APPLICATION FOR AMENDMENT TO A PLANNED UNIT DEVELOPMENT

APPLICATION #: **PUD26-0007**
APPLICANT: Board of Trustees of the Toledo Lucas County
OWNER: Board of Trustees of the Toledo Lucas County
LOCATION: 3027 Alexis Road
ZONING: Regional Commercial (CR)
NEIGHBORHOOD: Whitmer-Trilby
REPORT DATE: June 26, 2026
HEARING DATE: July 9, 2026
STAFF REVIEWER: Karcher

The applicant is requesting review of an Amendment to Planned Unit Development (PUD), originally granted by Ord. 150-25 & Ord. 439-25, for a new library at 3027 W. Alexis Road. The proposed amendment is for Phase III of the Washington Branch Library development and includes the existing building in the northwest corner of the subject property.

Proposed Landscape Plan:

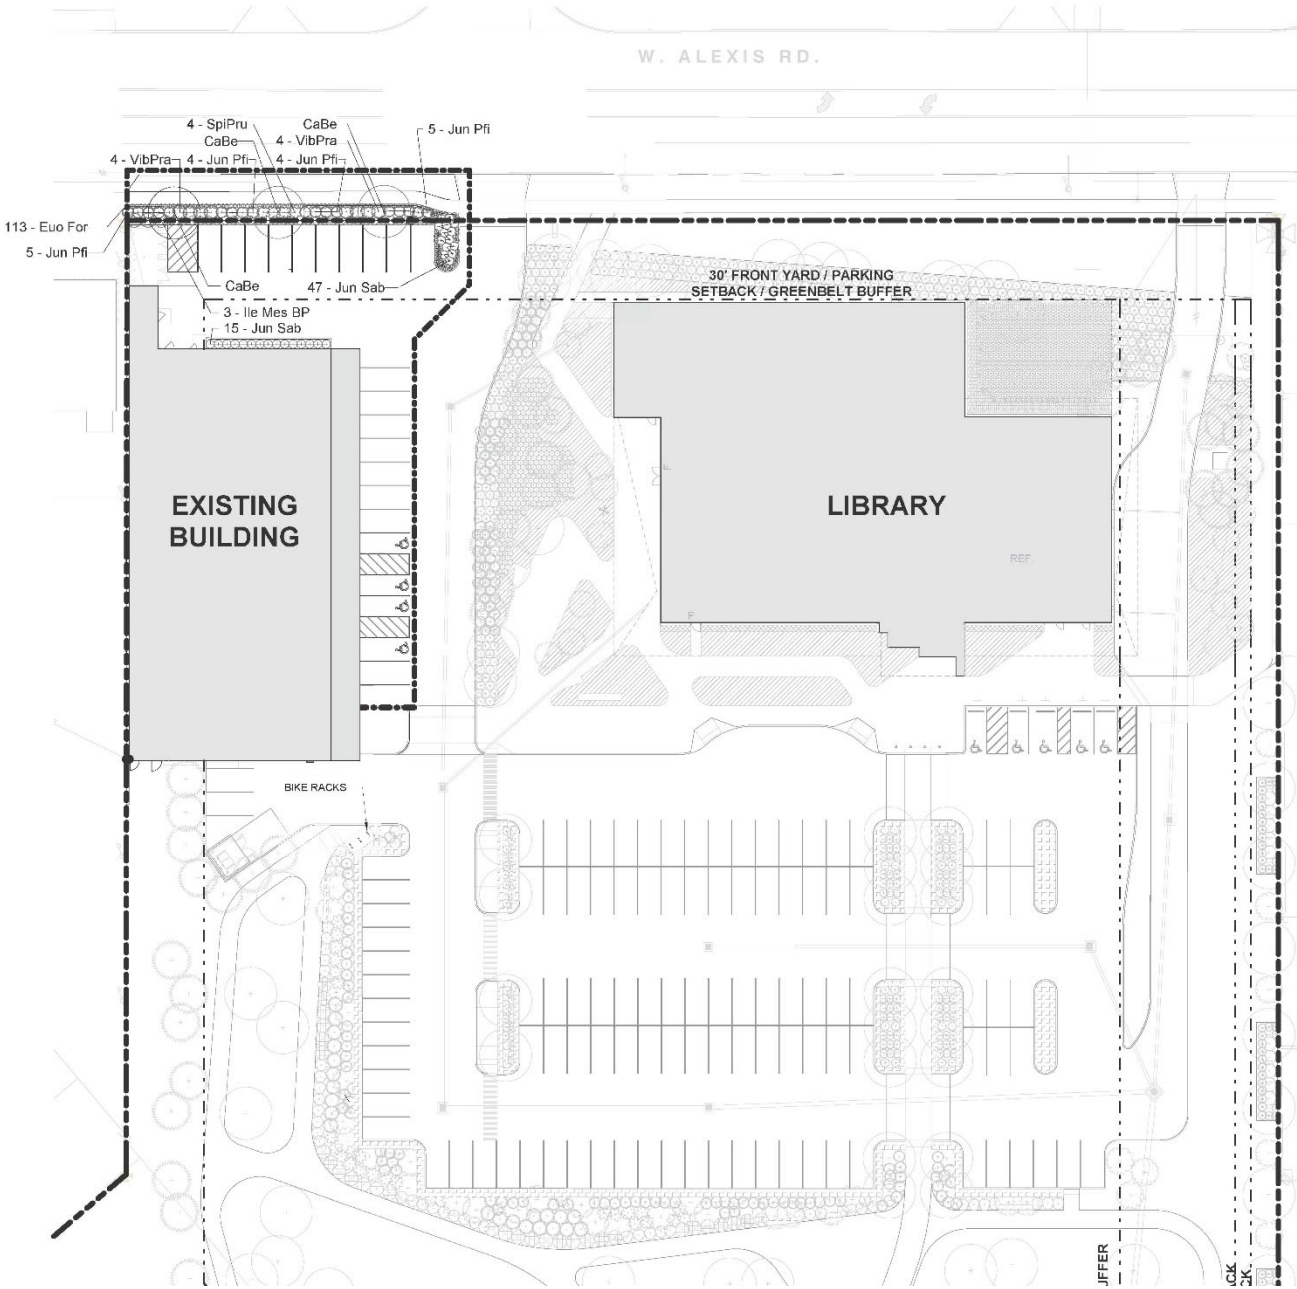
- (a) *Frontage Greenbelt (TMC§1108.0202)*. A minimum thirty-foot (30') wide frontage greenbelt along Alexis Road is required. The frontage greenbelt must contain four (4) trees and a solid evergreen hedge. The existing parking is situated along the property line; therefore, the required buffer can't be provided if the parking remains. A ± 8.0 foot landscape buffer with three (3) trees and a variety of shrubs is depicted on the landscape plan in the right-of-way immediately north of the parking spaces. – Not acceptable. A waiver is required for the greenbelt requirement. In addition, one (1) additional tree shall be provided and the proposed spirea shrub replaced with an evergreen shrub.

5. Wheel stops are required for all parking spaces along the perimeter of the parking lot as the lot extends to a property line, sidewalk, and/or planting strip per TMC§1107.1907. Wheel stops are required for the parking spaces along Alexis Road; however, none are depicted on the site plan. **Not acceptable as submitted.**

6. Dumpsters are not permitted in the required setback or landscape buffers and shall be located as far away from residential areas as possible per TMC§1108.0203(D). Two (2) dumpsters are proposed to be situated within the required thirty-foot (30') wide frontage greenbelt in the northwest corner of the property **Not acceptable as depicted. A waiver shall be secured or the dumpsters relocated to meet this requirement.**

- a. Per TMC§1108.0202, a minimum thirty-foot (30') wide frontage greenbelt along Alexis Road is required. The frontage greenbelt must contain four (4) trees and a solid evergreen hedge. The existing parking is situated along the property line; therefore, the required buffer can't be provided if the parking remains. A ±8.0 foot planting bed with three (3) trees and a variety of shrubs is depicted in the right-of-way immediately north of the parking spaces on the landscape plan. **Not acceptable as submitted. A waiver is required or the site plan revised to meet the frontage greenbelt requirement. In addition, one (1) additional tree shall be provided and the proposed spirea shrub replaced with an evergreen shrub.** If the waiver is granted, the applicant shall be responsible for maintaining the landscape buffer and ensuring that it does not encroach in the site distance setback in TMC§1107.2000.

- e. Per TMC§1103.1209(A.3), grade level mechanical equipment shall be screened from adjoining residential parcels and from the right of way(s).
- f. Per TMC§1108.0204(B.6), landscaped areas may not contain bare soil, aggregated stone, or decorative rock. Any ground area must be covered with hardwood mulch, grass, or other vegetative ground coverage. The proposed rock mulch is not permitted.
